## V2500-A1 SERIES PROPULSION SYSTEM NON-MODIFICATION SERVICE BULLETIN

This document transmits Revision 1 to Service Bulletin EV2500-73-0188

# V2500-ENG-73-0188

NON-MODIFICATION SERVICE BULLETIN – ENGINE – EPR MODIFIER CLASS CORRECTION DUE TO  
TEST CELL CALIBRATION SHIFT

Location of the Engine Identification Plate (Ref. Catalog Sequence No. 72-32-85,  
Figure 3, Item 120)  
Figure 2

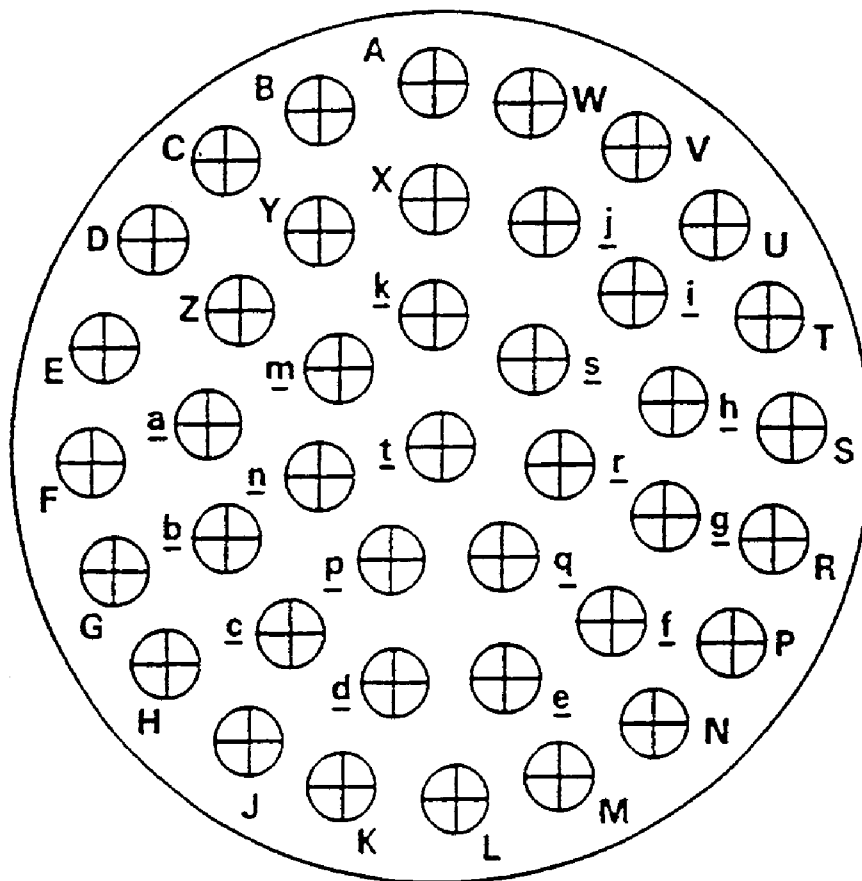
- (a) Remove the four bolts that secure the old Engine Identification Plate to the bracket located on the fan case at the 9 o'clock position. See Figure 2.
  - (i) Return the old Engine Identification Plate to the IAE representative.
  - (ii) Obtain a new Engine Identification Plate from the IAE representative.
- (b) Install the new Engine Identification Plate to the bracket located on the fan case at the 9 o'clock position with part number 4W0102 Bolts (4 off). See Figure 2.
- (c) Torque bolts between 32-36 lbfin (3,61-4,07Nm).

Contact Hole Locations  
Figure 1

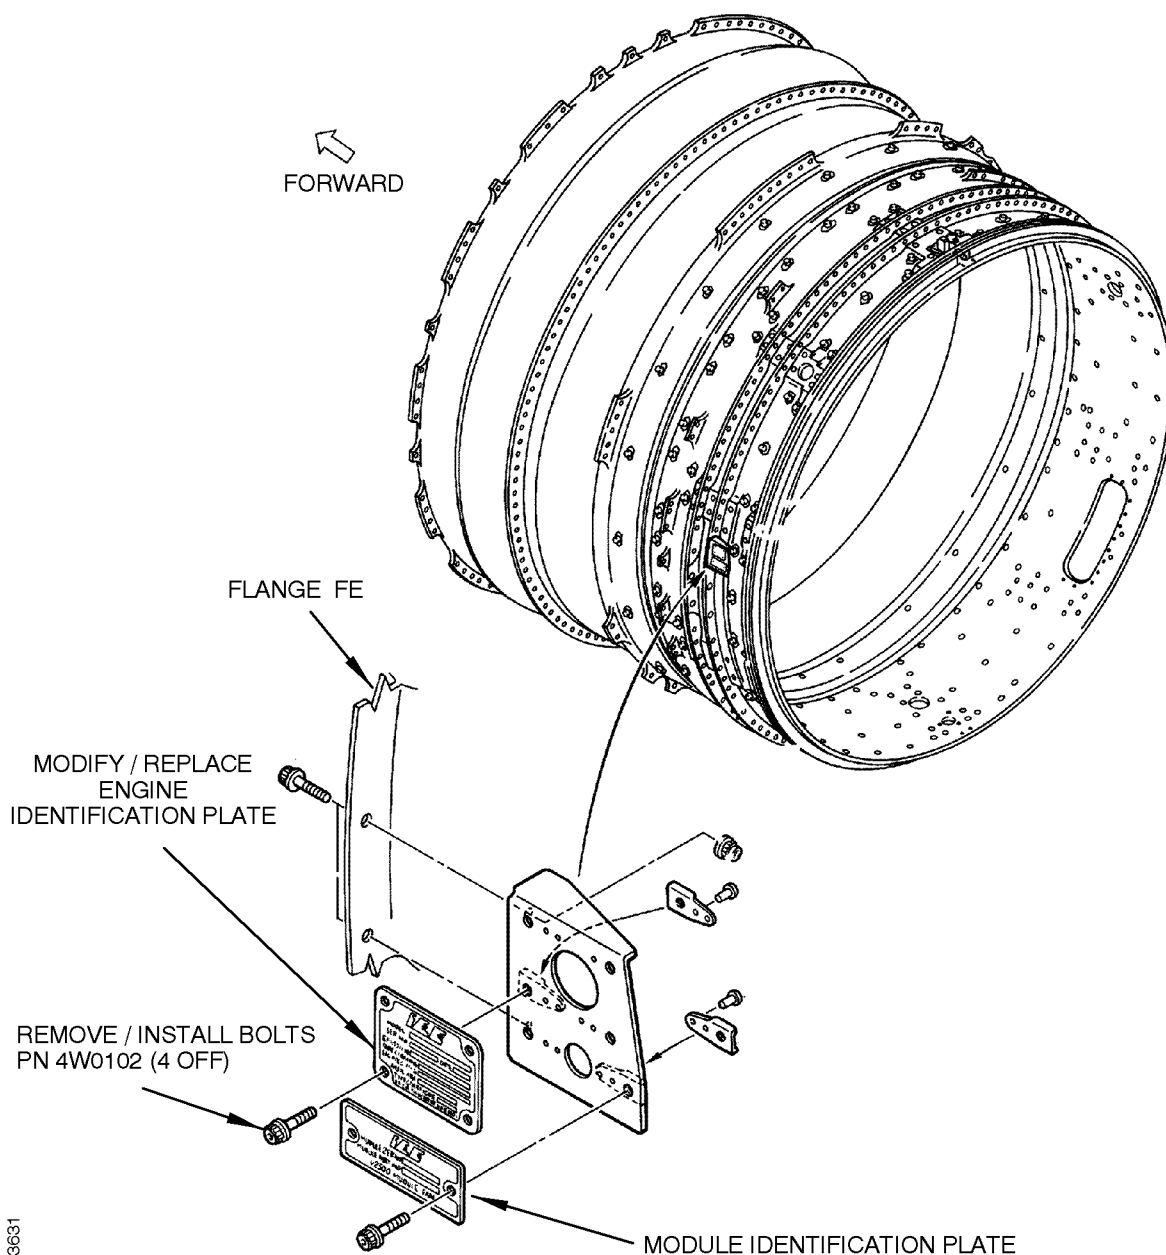
- (a) Disassemble the DEP Assembly per procedure specified in AMM 73-22-35-801.
- (b) Make two photo copies of Figure 1 of this Service Bulletin, Contact Hole Locations.

- (c) Mark all existing jumper connections from the DEP connectors on one copy of the figure and label it 'Pre SB 73-0188 Pin Connectors'.
- (d) Find the existing EPR Modifier Class marked on the DEP and confirm that the Data Entry Plug wiring agrees with the jumpers according to Table 2.

- (e) Find the new EPR Modifier Class for the engine serial number in Table 1.
- (f) Mark the jumper locations for the new EPR Modifier Class on the second copy of the Contact Hole Location Sheet. Mark all other existing jumper locations that are not affected by the EPR Modifier Class Change. Label this copy 'Post SB 73-0188 Pin Connectors'.
- (g) Remove the jumpers to change from the existing EPR Modifier Class and install the jumpers needed for the new EPR Modifier Class according to the procedures in AMM 73-22-35-801.
